No.	Date	Description
1	2025-09-19	Add No. 1
2	2025-09-30	Add No. 2

**WCFPD Station 3**  
**Wright City Fire Protection District**  
9 Highway WW  
Wright City, MO 63390

**JOINTING PLAN**

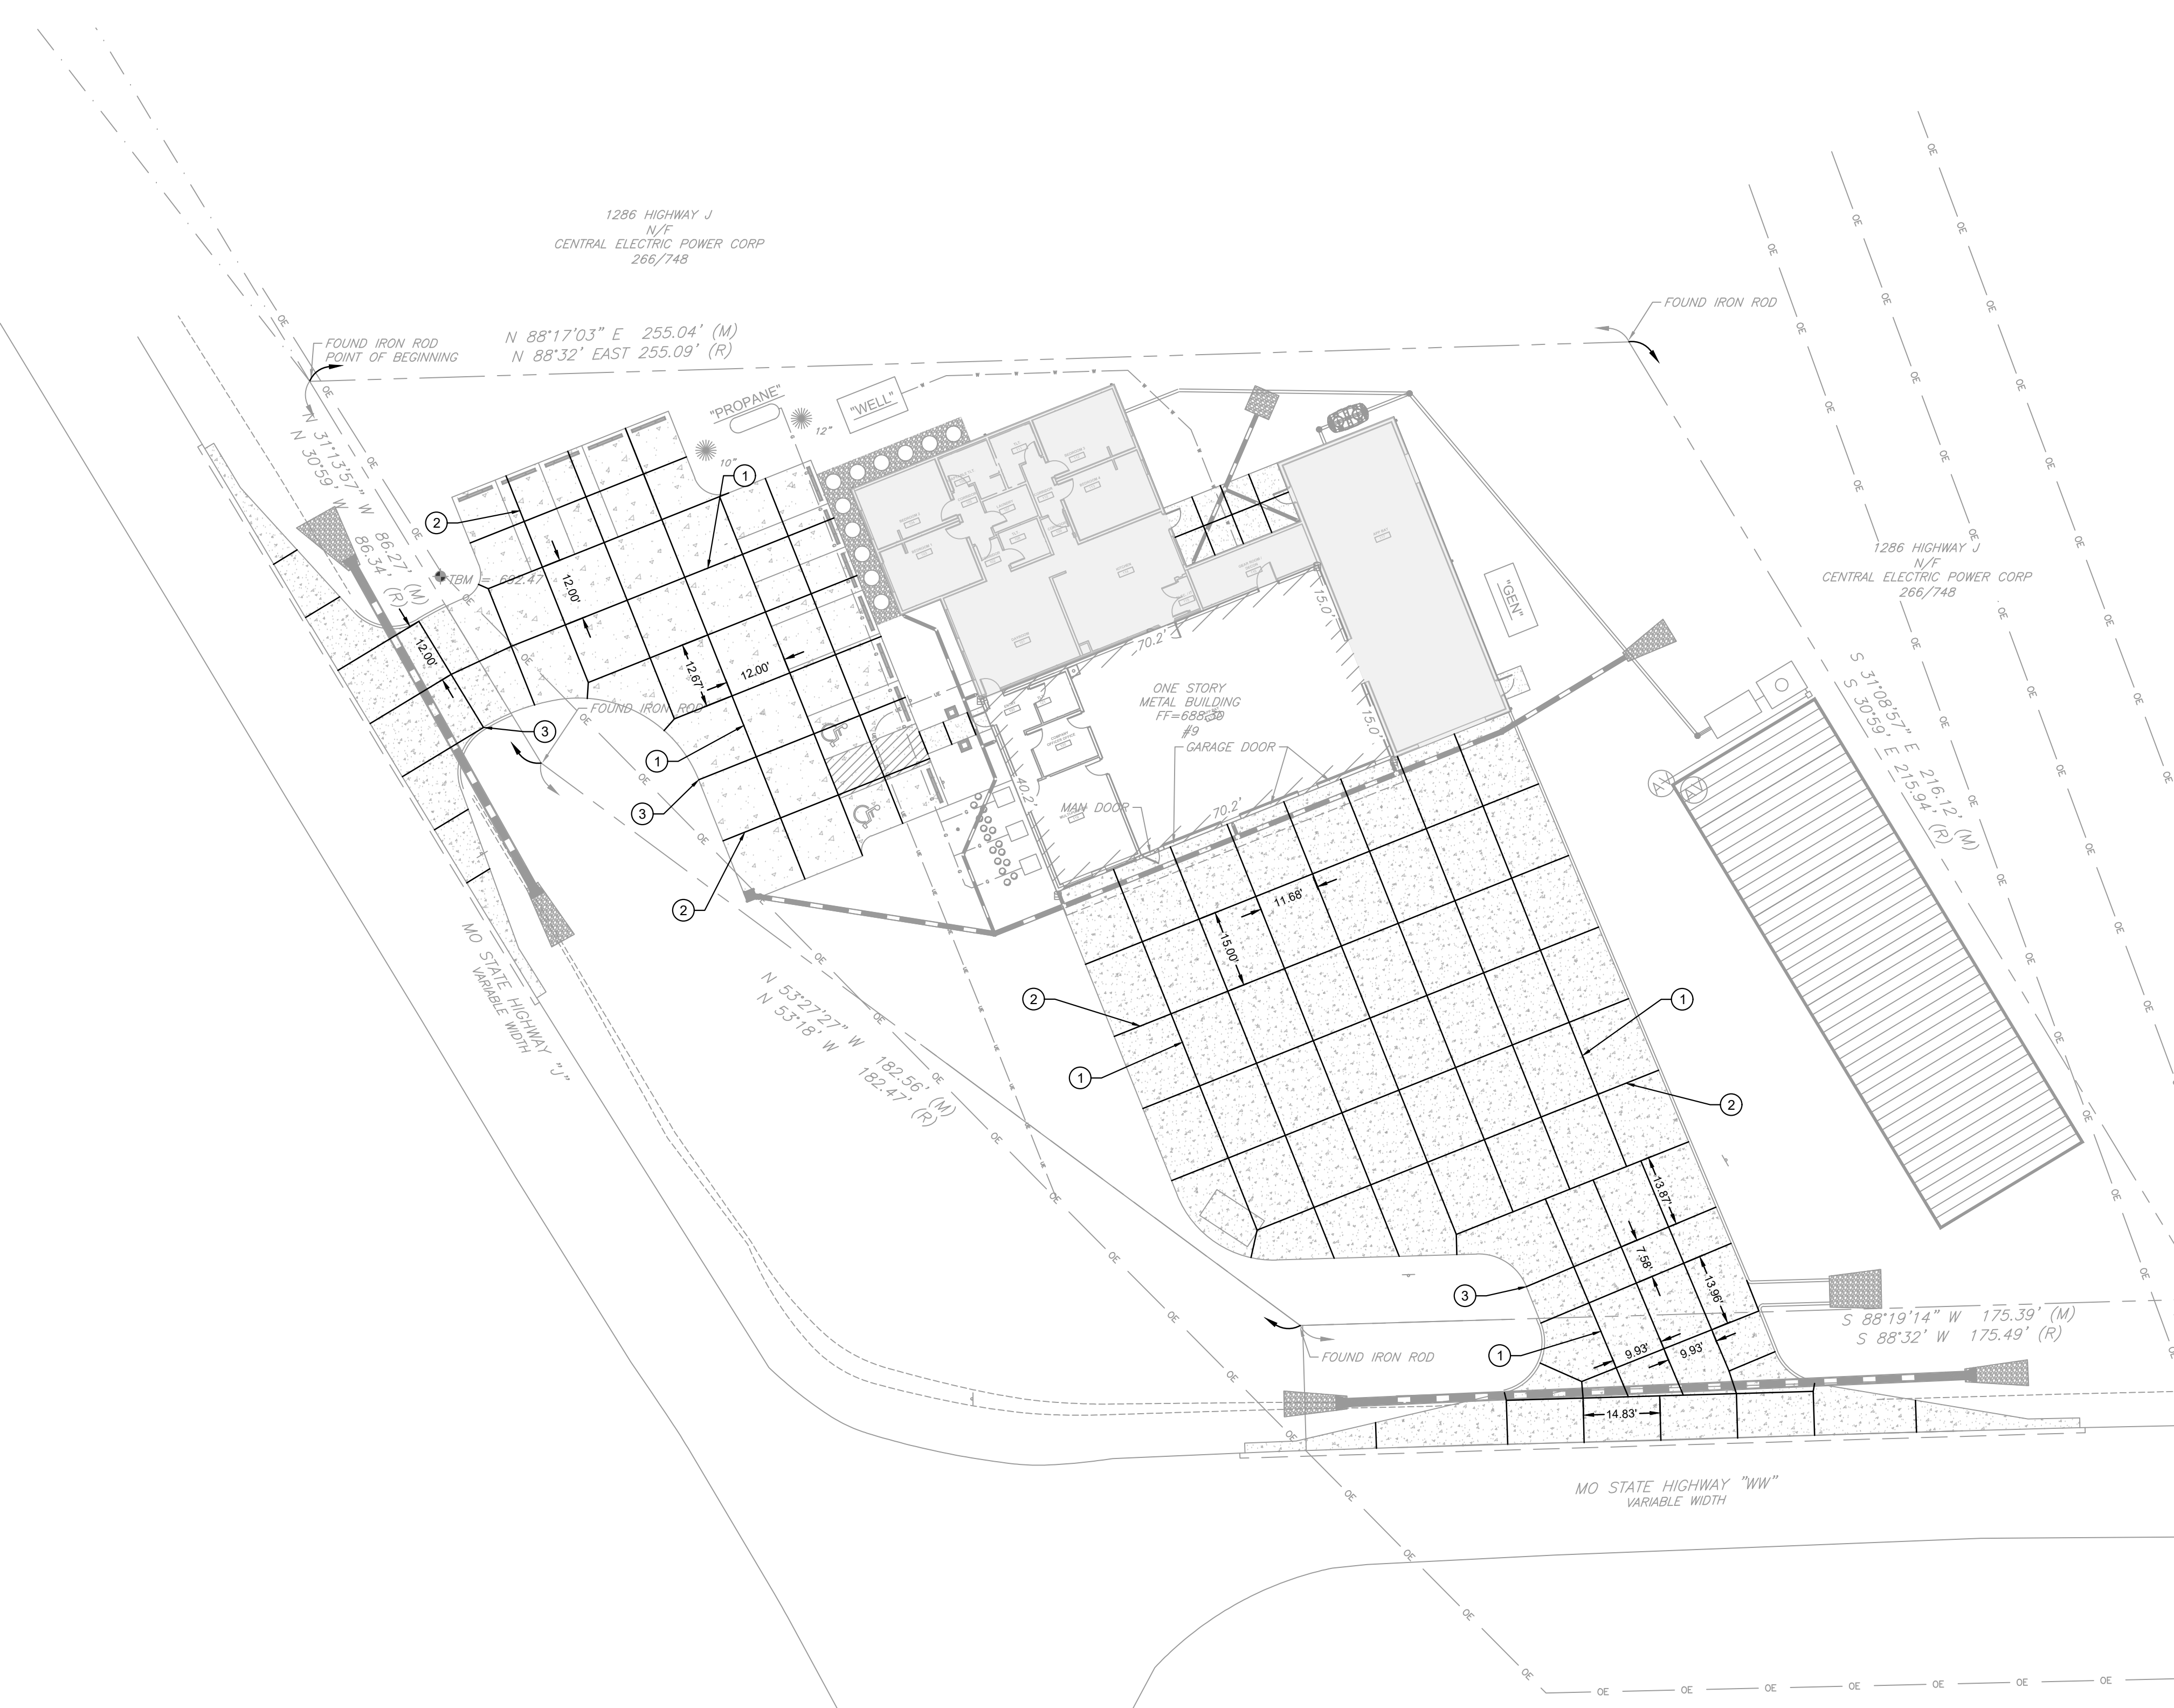
- 5) Sheet C201 – JOINTING PLAN
  - a. ADD new sheet.
- 6) Sheet C300 – GRADING PLAN
  - a. ADD spot shots for the corrected pavement.
  - b. REVISED grading on the living quarters side.

SOIL REMEDIATION PLAN	
Drawn By:	WTS
Checked By:	SMA
Project#:	25-0170
Date:	2025-09-30

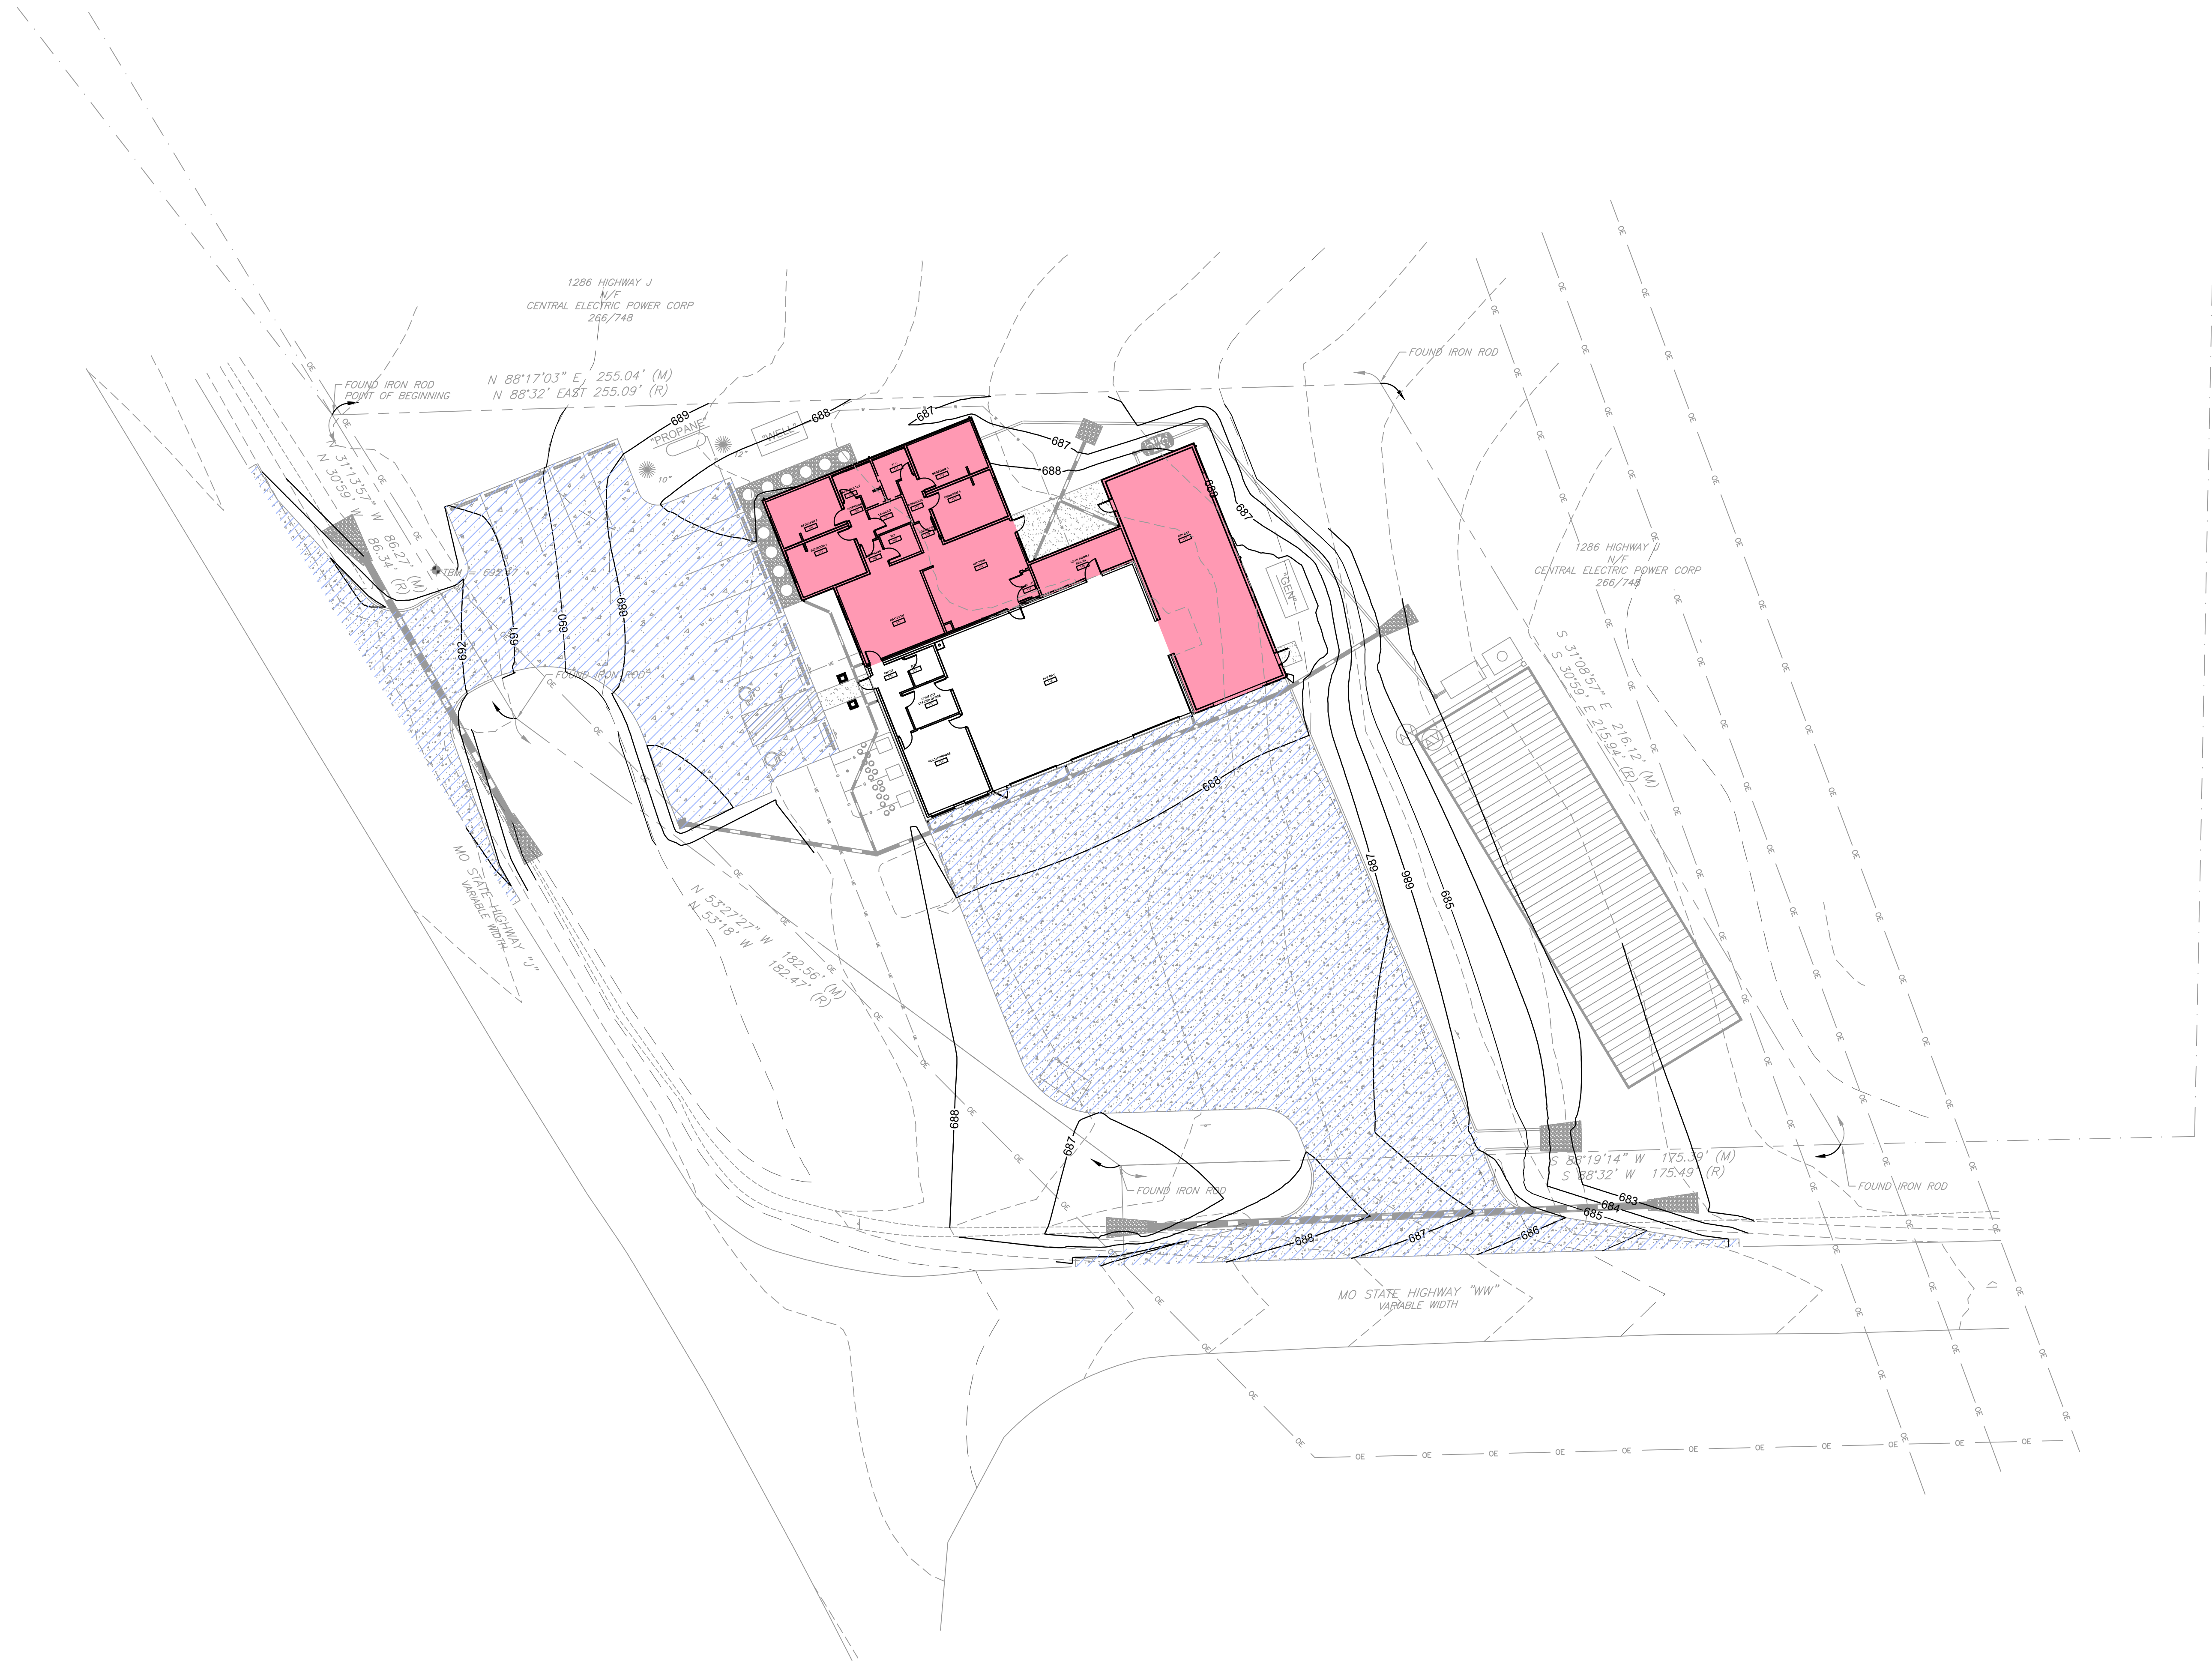
- 7) Sheet C302 – SOIL REMEDIATION PLAN
  - a. ADD new sheet.
- 8) Sheet C500 – UTILITY PLAN
  - a. ADD a propane tank to the plans and show gas line to the condensers.

**UTILITY PLAN**

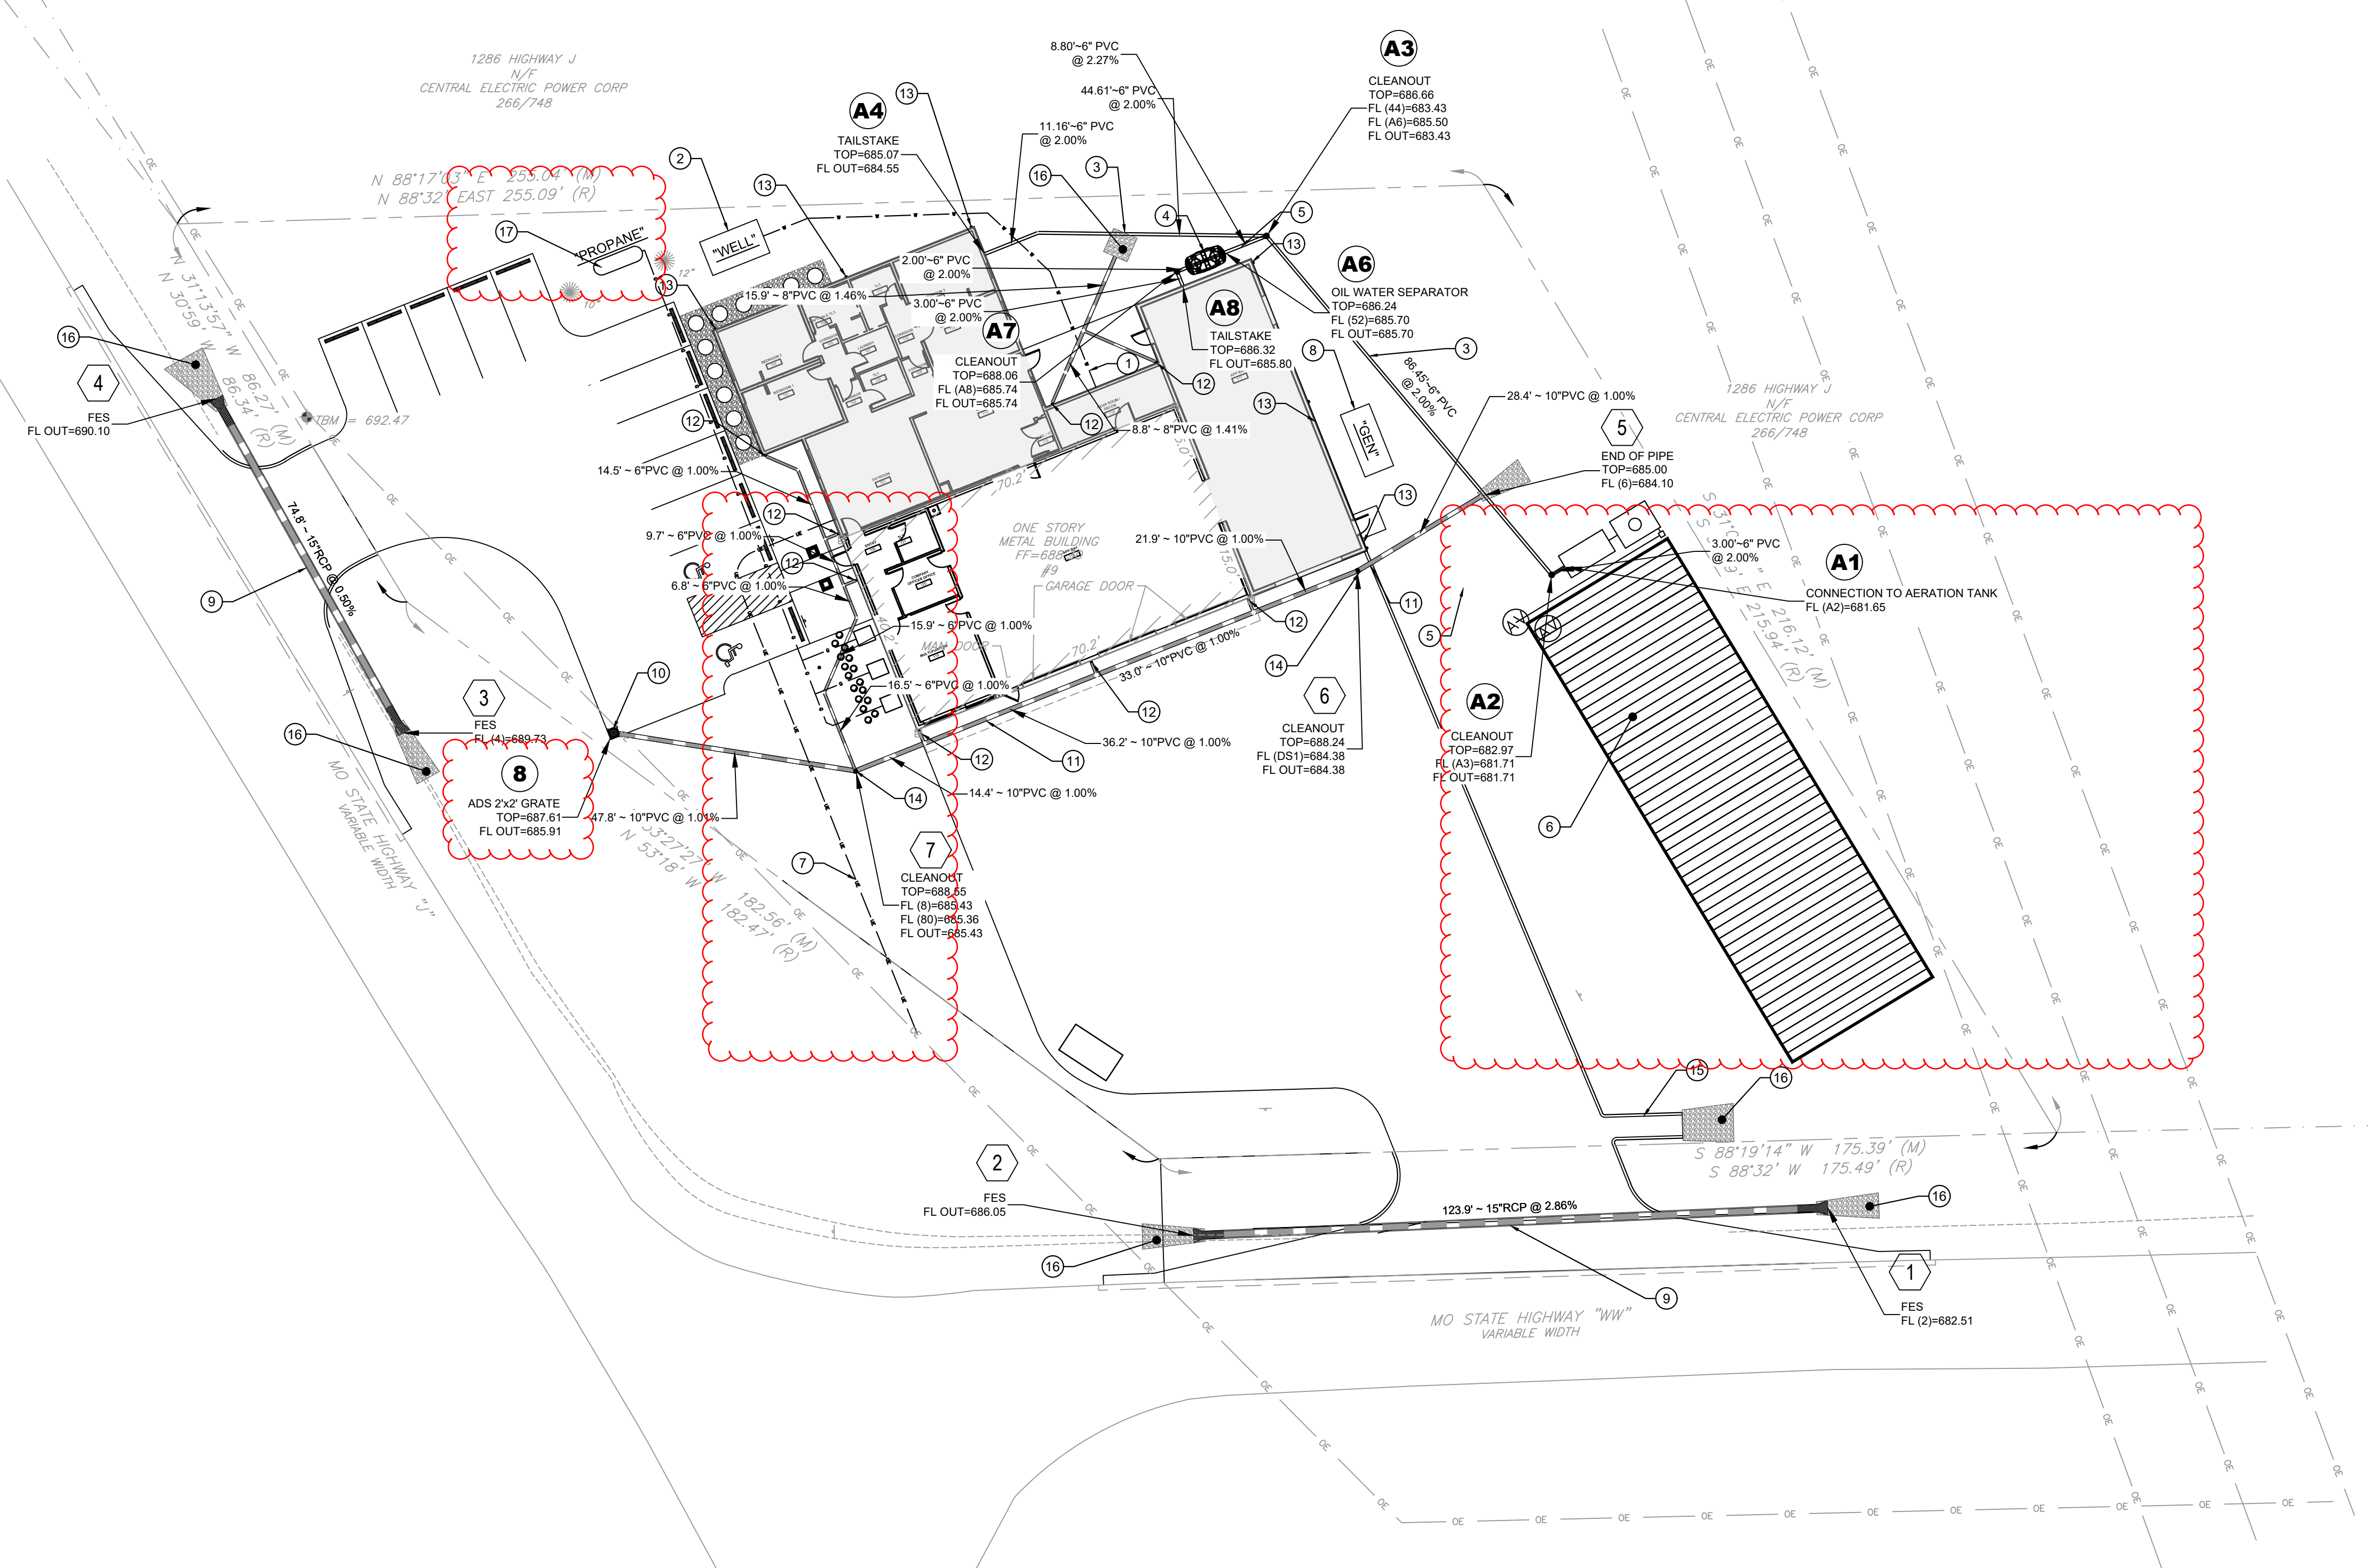
- b. REMOVED the trench drain and added an ADS inlet.
  - c. REVISED the layout of the septic field to match the design by the septic engineer.
  - d. REVISED the route of the underground electric.
